Access Compliance Report Public Rights-of-Way (Curb Ramps)

Main Street: WALLINGSFORD_RD Cross Street: ORANGEWOOD_AVE Location: SW

ADA ID: RPRK211215143034 Ramp Type: Type 4 - Parallel Initial Pass/Fail: Fail Overall Compliance: No Severity Score: 15

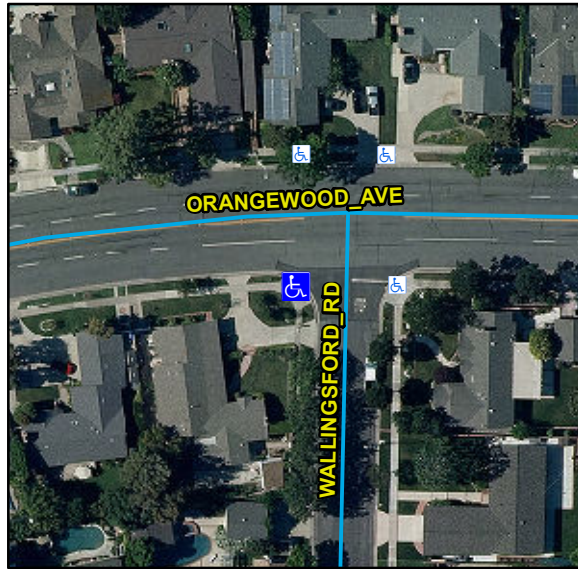
Compliance	Description	Data	Compliance	Description	Data
N/A	Ramp Length LT (in)	108	N/A	Ramp Length RT (in)	110
Yes	Ramp Width LT (in)	100	Yes	Ramp Width RT (in)	100
Yes	Ramp Run Slope LT (%)	5.8	Yes	Ramp Run Slope RT (%)	4.8
No	Ramp Cross Slope LT (%)	3.1	No	Ramp Cross Slope RT (%)	6.6
N/A	Landing Present	N/A	N/A	DWS Provided	N/A
N/A	Landing Length (in)	N/A	N/A	DWS Contrast	N/A
N/A	Landing Width (in)	N/A	N/A	DWS Length (in)	N/A
N/A	Landing Run Slope (%)	N/A	N/A	DWS Full Width	N/A
N/A	Landing Cross Slope (%)	N/A		DWS Offset Type	N/A
N/A	Landing Movement Obstructed?	N/A	N/A	DWS Offset Left (in)	N/A
	Landing Movement Type	N/A	N/A	DWS Offset Right (in)	N/A
N/A	Landing Shared	N/A			
N/A	Clear Space	Yes			
N/A	Clear Space To Crosswalk (in)	N/A			
N/A	Marked Crosswalk 1	No	N/A	Marked Crosswalk 2	No
	Crossing 1 Direction	E		Crossing 2 Direction	N
	Marked Crosswalk 1 Width (in)	N/A		Marked Crosswalk 2 Width (in)	N/A

Remove & Replace Curb Ramp With Two New Directional Ramps or Equivalent.
